**Agilent Technologies ESA-L1500A Spectrum Analyzer
Power Supply Upgrade Kit Number E4411-60021**

Part Number E4411-90047 Supersedes E4411-90042

E4411-60021 Power Supply Upgrade

Figure 7 Power Supply Assembly 1

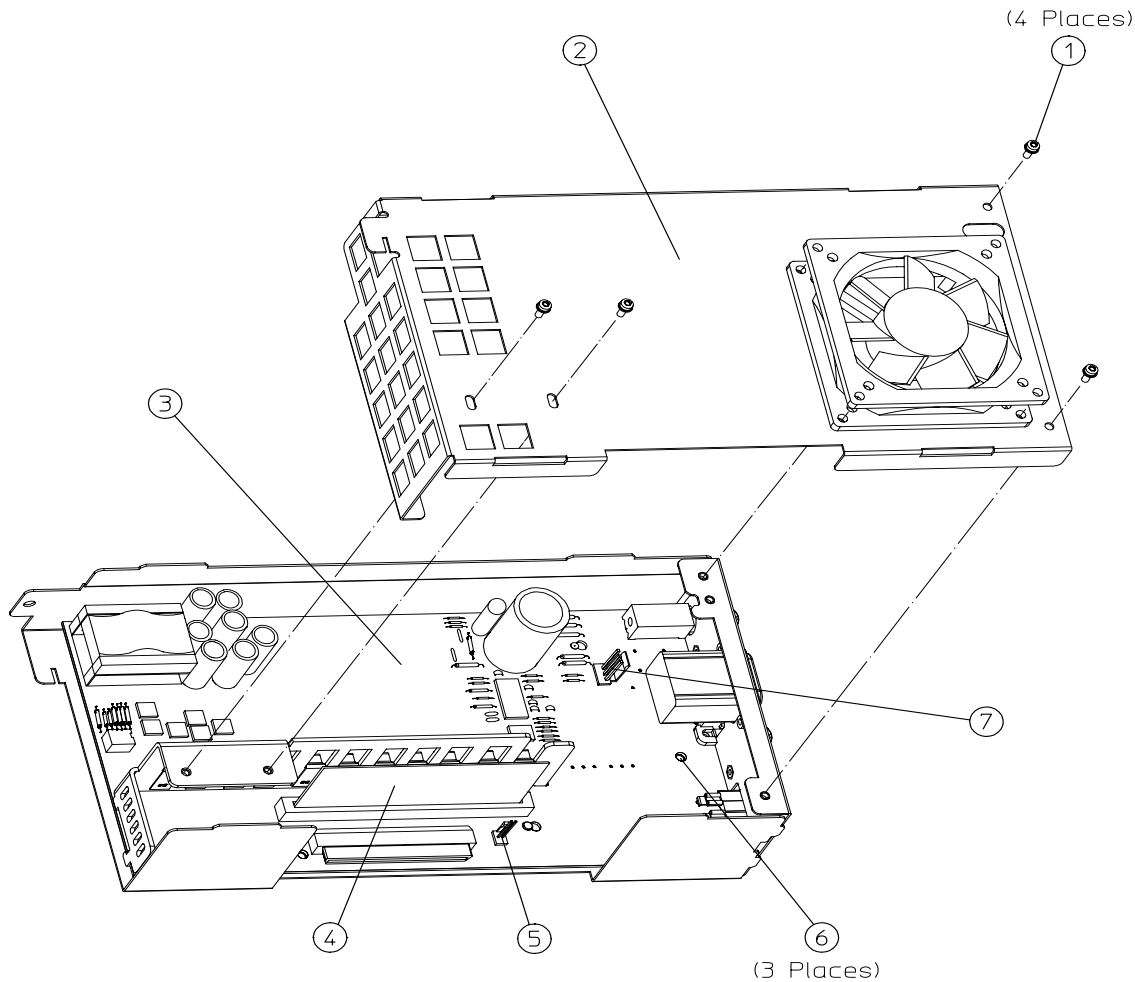
1. Replace the power board (3) onto the casing, and secure with the three screws (6).
2. Place the new label (9320-6209) over the barcode label on the power board.
3. Remove the controller daughter board (E4401-60063) (4) from J7 and replace with the new controller board (E4411-60090).
4. Plug in the incoming power line (7) to the power board (3).
5. Replace the power supply cover (2), with fan, on the power supply assembly. Make sure the lip on the top cover catches underneath the bottom cover.
6. Replace the four screws (1) that secure the top cover to the power supply assembly. Torque to 101 N/cmN/cm (9-inch pounds).
7. Plug the fan connector (5) into the power supply board (3).

Figure 8 Power Supply Assembly 2

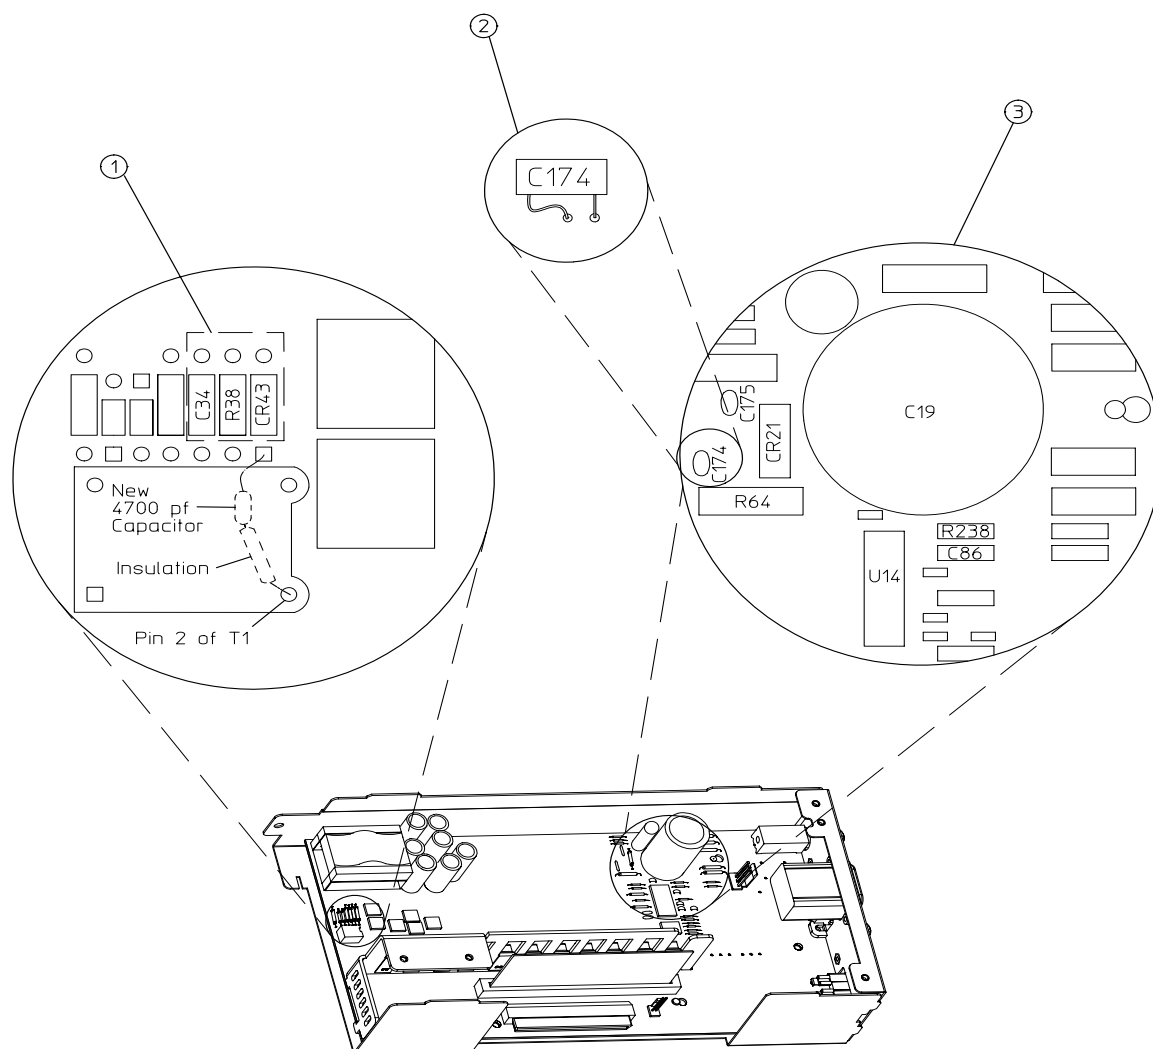
6. Unsolder and remove C34, R38, and CR43 (1).
7. Solder the two 10 ohm resistors (0757-0346) in place of C34 and R38.
8. Place the insulation sleeve (0890-0099) over one lead of the 4700 pF capacitor (0160-4831). Turn the board over. On the back of the board, solder the 4700 pF capacitor (0160-4831) from pin 2 of T1 to the cathode pad (square pad) of CR43.
9. Unsolder and remove C86, R238, and C174 (3).
10. Solder the 1 ohm resistor (0698-8812) in place of R238.
11. Solder the 1000 pF capacitor (0160-4574) in place of C86.
12. Place two 90° bends—as shown in Figure 8 at (2)—in one lead of the 4700 pF capacitor (0160-4439). Insert the capacitor into the board in the place of C174 with the bent lead closest to the edge of the board. Solder it in place.
